Subject: Appeal of Planning Commission's Approval of Site and Development Plan Petition No. 22-40SP for the Development of a Shopping Center in the Milano PUD Located at the Southwest Corner of Laurel Road and Jacaranda Boulevard

Subject: Appeal of Planning Commission's Approval of Site and Development Plan Petition No. 22-40SP for the Development of a Shopping Center in the Milano PUD Located at the Southwest Corner of Laurel Road and Jacaranda Boulevard

SUBJECT: Safety and stormwater concerns: *Village at Laurel and Jacaranda Site and Development Plan Petition No. 22-40SP*

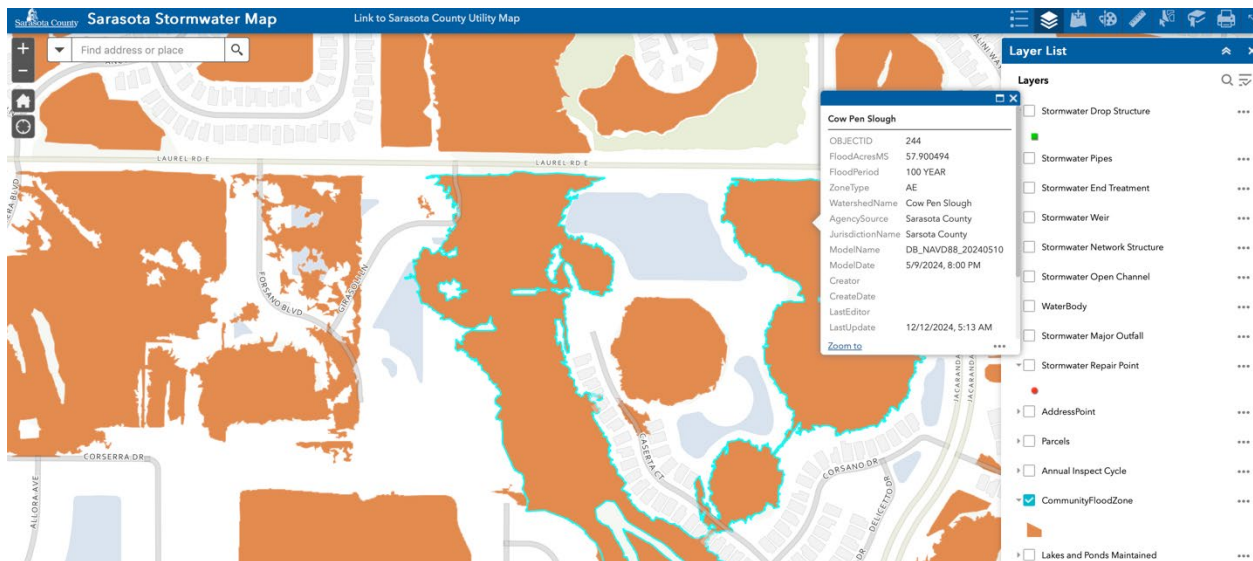
Another important item which must be addressed are the flood zone maps. Currently, FEMA shows the subject 10.4 acres as Zone X. It should be noted that this is based on information from 2014. The Sarasota County Flood Hazard Area map, which is current up to 2020, classifies the

wetland which will be filled and made impervious, as well as the wetlands adjacent to Cielo, as being in Flood Zone AE.

Once Pond LL-4 and the wetland are filled, there will be no floodplain compensation when a 100-year/24-hour storm is considered. With no proposed modification of Pond LL-7, and this flood zone information, it begs the question “where will this water go and are the adjacent homes at risk?”
